RGDSS Memorandum FINAL

Subject: RGDSS Peer Review: Hydrogeologic Review of Manassa Fault and

McIntire Spring, Conejos County, CO

Date: October 20, 2015

Figure 4

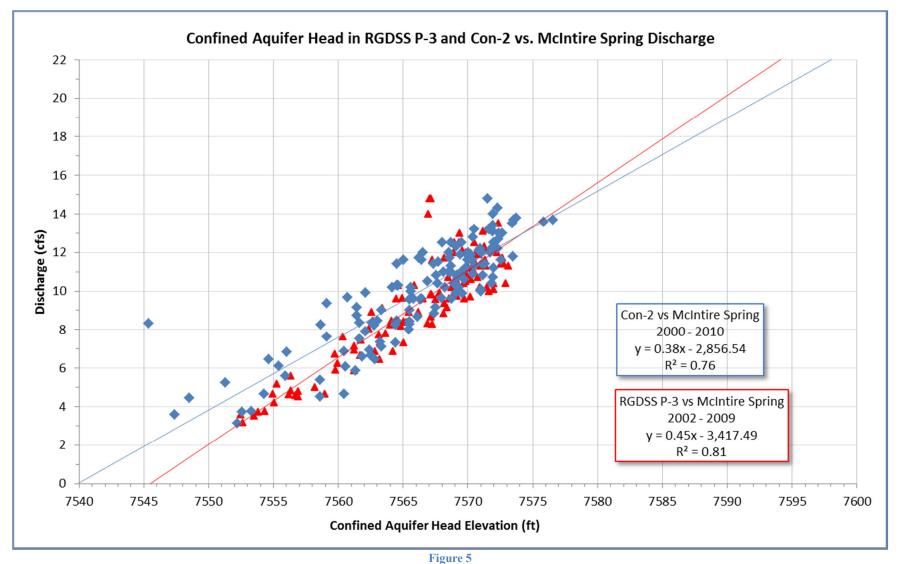
As shown on Figure 4, since approximately 2000 a seasonal or longer-term rise or fall of 1 foot of confined aquifer head in nearby confined aquifer wells correlates quite closely to a seasonal or longer-term increase or decrease in the range of 0.38 to 0.45 cubic feet per second (cfs) of discharge at McIntire Spring, based on comparison with RGDSS P-3 and monitoring well CON-2, respectively. The P-3 relationship to McIntire Spring discharge (R² = 0.81) is slightly stronger than the CON-2 relationship to McIntire Spring discharge (R² = 0.76), even though CON-2 is about ½ mile nearer to McIntire Spring (see Figure 5). This may be because RGDSS P-3 had daily records, and so the head measurements could be correlated to the same date as the McIntire Spring measurements. The frequency of CON-2 measurements and McIntire Spring measurements both varied from about 2 to 4 weeks, generally averaging about 3 weeks between measurements. For this comparison we chose CON-2 head observations and McIntire Spring

The strong seasonal and longer-term correlation, with no discernible lag time between change in nearby confined aquifer head and change in McIntire Spring discharge, suggests that McIntire Spring is sourced primarily, if not entirely, from the confined aquifer. It also suggests that the P- $3 / \text{CON-}2 / \text{McIntire Spring locality of the confined aquifer is of high transmissivity and low storativity, an observation corroborated by the results of the RGDSS P-3 aquifer test (T = <math>270,000 \text{ ft}^2/\text{day}$, S = 2.3×10^{-3}) ⁸.

- The linearity of the relationship between confined aquifer head and McIntire Springs discharge across the entire range of observed discharge approximately 3.1 cfs (August, 2002) to 21.3 cfs (July, 1949) strongly suggests that all, or at least a large majority, of McIntire Spring discharge has its source in the confined aquifer. If there were a substantial contribution of McIntire Springs discharge from the unconfined aquifer or from surface water sources, and if the elevation of those near-surface sources remained relatively constant over time, the head versus discharge relationship (Figure 5) would be expected to 'flatten' and be asymptotic to the surface water or unconfined source contribution in the lower range of discharge. This is not seen in the observed data.

Figure 13. McIntire Spring Cross-Section

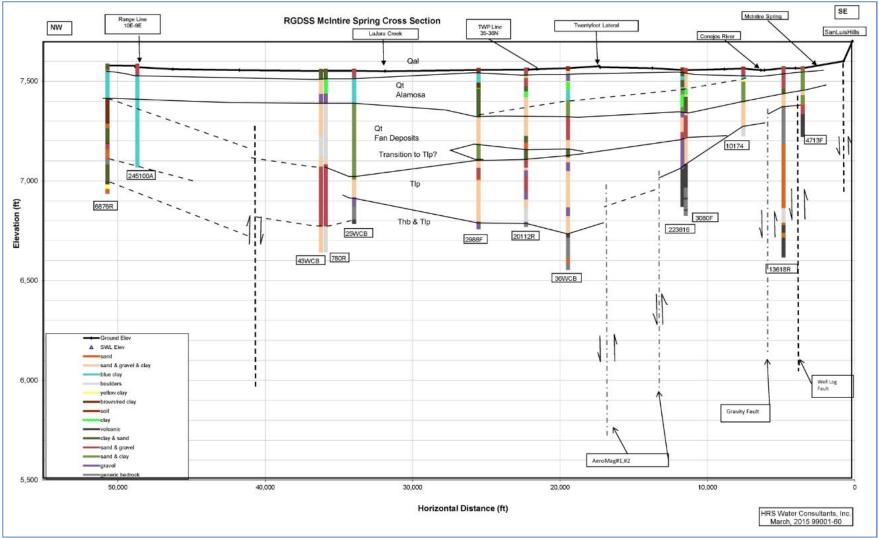
The McIntire Spring Cross-Section (see Figure 13) shows a general thickening in sediment northwestward (basinward), which was expected based on our previous mapping in this area. The confining clays (Qala) thicken westward as well. The Hinsdale Formation (Thb, Tlp) volcanics are deeper at each indicated fault location, indicating generally good agreement

between the USGS geophysical survey interpretations and HRSø interpretations based on the well logs. The deepest volcanic unit identified was in 36WCB, at an elevation of 6,726 ft above mean sea level (MSL). Progressing northwest along this cross section, volcanic rocks appear to trend upward or are faulted upward at the location of 25 WCB as they are found at an elevation of 6816 ft MSL.

Figure 14. LaJara-Sanford Cross-Section

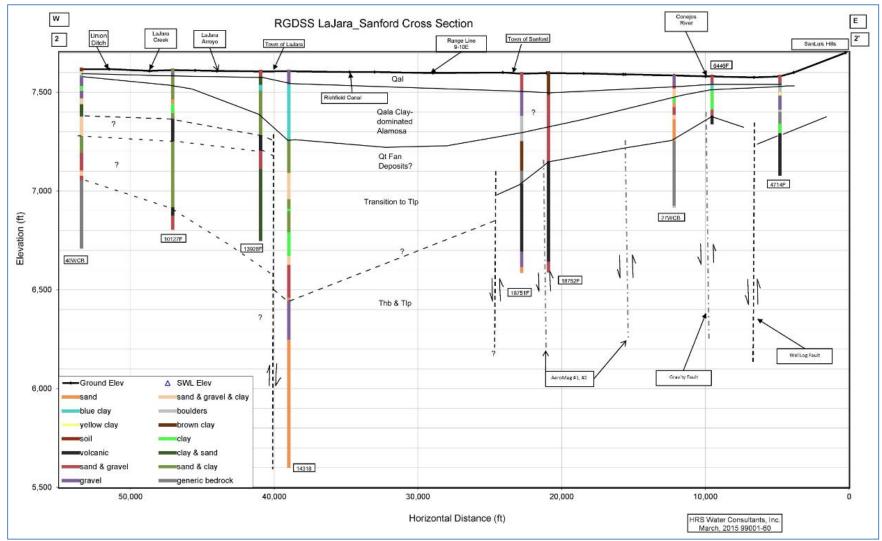
The La Jara-Sanford Cross-Section (see Figure 14) shows a general thickening of sediments, in particular the clay layers (Qala), westward (basinward) similar to the McIntire Spring Cross-Section. Hinsdale Formation (Thb, Tlp) volcanic rocks appear to be more laterally persistent near the La Jara Cross Section with the deepest found in well 18752-F. These rocks are at an elevation of 7094 feet, which is significantly higher than those corresponding to a similar location (in reference to the Aeromagnetic faults) along the McIntire Spring Cross Section. The western portion of the cross section is similar in structure to the McIntire Spring cross section, with thick sediments at well 14318 (considered analogous to wells 780R and 43WCB in the McIntire Spring Cross-Section). However, further west is well log evidence of volcanic rocks at much higher elevations, e.g. wells 10127F and 13928F. If so, this may lend credence either to the La Jara Fault per Moravec et al. (1978) located between wells 14318 and 13928F, or to the distal depositional edges of Hinsdale lava flows. Evidence for the presence of a fault in this vicinity may also exist in the McIntire Spring Cross-section with the presence of volcanic rocks in 25 WCB and sediments in 43WCB and 780R. Well 6876R (McIntire Springs Cross section) indicates a thin bed of volcanic rocks at 7,008 feet MSL; however, it is unclear whether these volcanic rocks were erroneously identified, or are thin and discontinuous, due to lack of corroborative evidence in surrounding wells.

Figure 15. Map of Faults and Cross-Sections

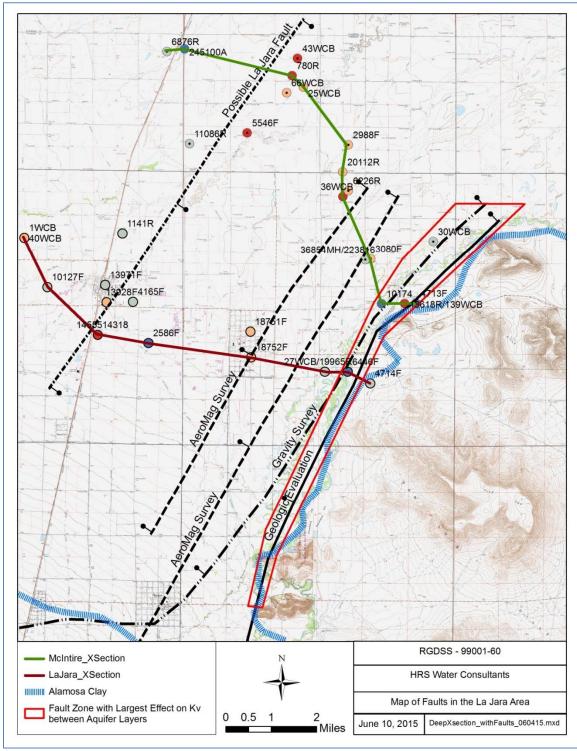
- 5. Work done for this review lends credence to the postulated presence of the La Jara Fault, NE trending through the La Jara area, downthrown to the southeast (Moravec et al, 1978), and the possible presence of a shallow graben bounded on the SE by the Manassa Fault zone and on the NW by the La Jara Fault. This possible graben has been shown to contain confining layers consisting of Alamosa Formation fluviolacustrine sand and clay deposits that generally thicken to the NE (HRS, 2012). A map view of the interpreted locations of the faults that bound this postulated graben is shown on Figure 15.

1. The Manassa Fault should be represented in the model as a zone of elevated hydraulic conductivity in Layers 2 and 3, approximately in the area shown on Figure 15. Such a zone is reasonable, because from geologic and geophysical evidence the Manassa Fault zone appears to crosscut volcanic rocks and sediments that comprise Layer 3. Based on

2. Based on this review, evidence from well logs and from USGS geophysical survey interpretations lend credence to the postulated presence of the La Jara Fault, NE trending through the La Jara area, down to the southeast; per Moravec et al, (1978); the possible presence of a shallow graben bounded on the SE by the Manassa Fault zone and on the NW by the La Jara Fault; thickening of Los Pinos or Santa Fe Formation sediments beneath the Mogote volcanic shield and the La Jara / Alamosa alluvial fans; and thinning of Los Pinos or Santa Fe sediments generally south of State Highway 142 (Romeo ó Manassa area). It is advisable that the model layering in these areas be reviewed for needed updates to improve the conceptual hydrogeology as depicted in the RGDSS ground water model.
